LiDAR Quality Assessment Report

SC_Saluda_2010

B. Swain

Figure 2: Checkpoints distribution for the current delivery for Saluda County, SC.

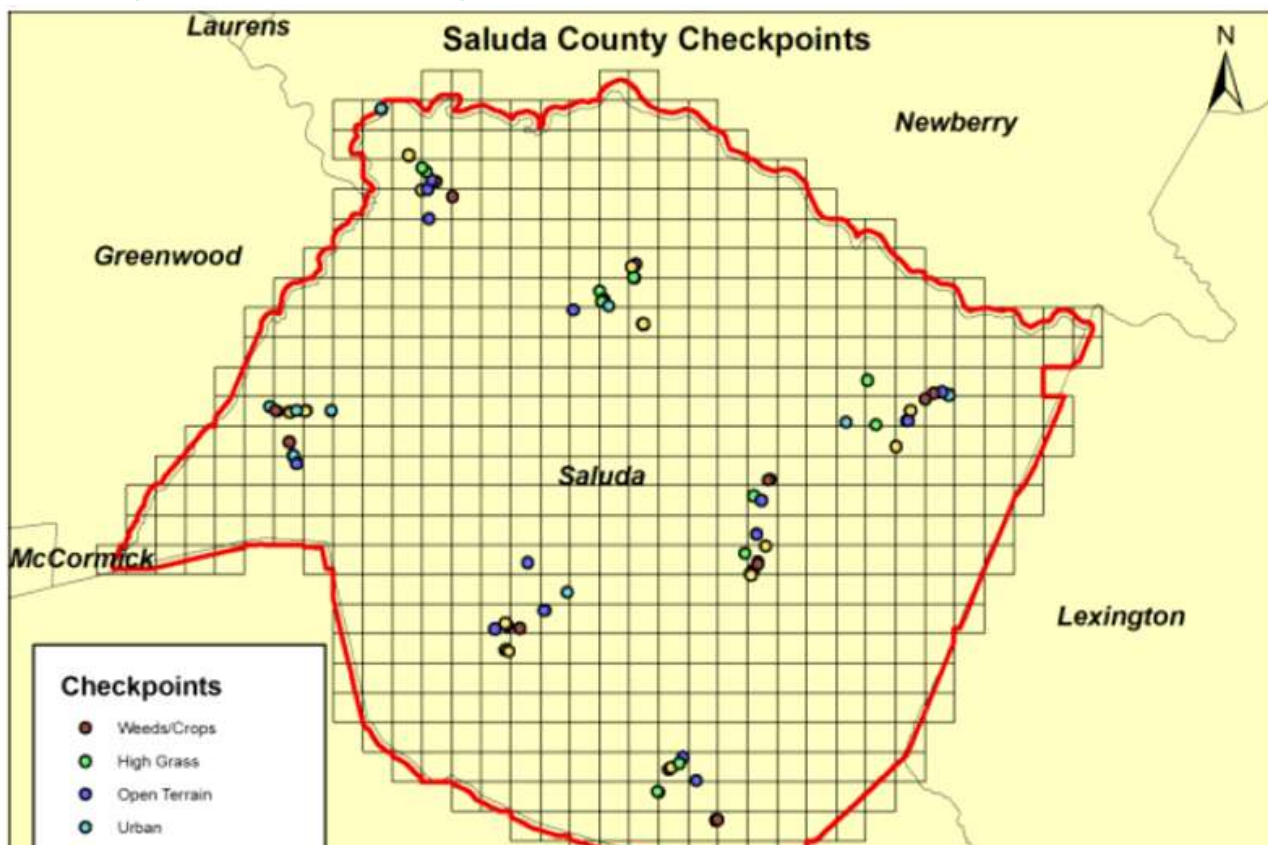
There are a minimum of 20 checkpoints for each land cover class represented. Points within each class are uniformly distributed throughout the dataset. USGS was not able to locate independent checkpoints for this analysis. USGS does not accept at this time the quality of the checkpoint data for these LiDAR datasets.

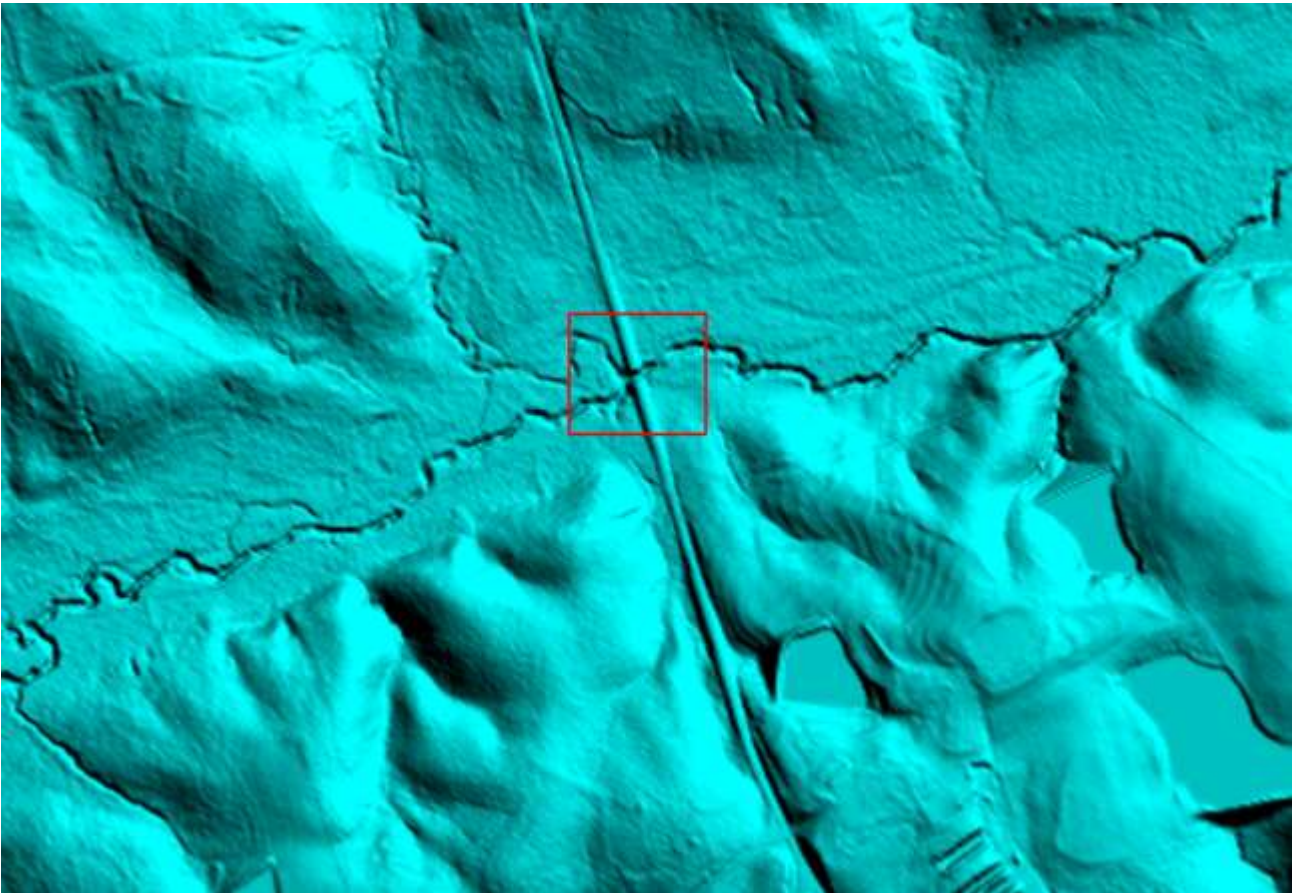
Removal of what appears to be a culvert, though whether it is a small bridge or culvert remains somewhat ambiguous, and it cannot be fully determined by NGTOC using ancillary data.
